<b>AMENDMENT OF SOLICITATION/MODIFICATION OF CONTRACT</b>				1. CONTRACT ID CODE <div style="text-align: center;">J</div>		PAGE OF PAGES <div style="text-align: center;">1   6</div>

2. AMENDMENT/MODIFICATION NO. <div style="text-align: center;">0007</div>		3. EFFECTIVE DATE <div style="text-align: center;">05-Apr-2009</div>		4. REQUISITION/PURCHASE REQ. NO.		5. PROJECT NO.(If applicable)

**FINAL ROUND OF QUESTIONS AND**

CSB Conceptual Master Plan  
Kandahar Afghanistan

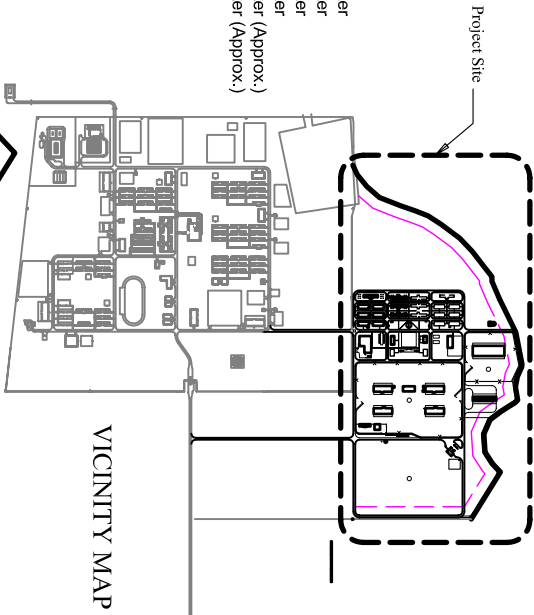
Is it acceptable to construct the interior partition walls of building without reinforcement ?

All construction must be in accordance with applicable contract referenced design requirements.
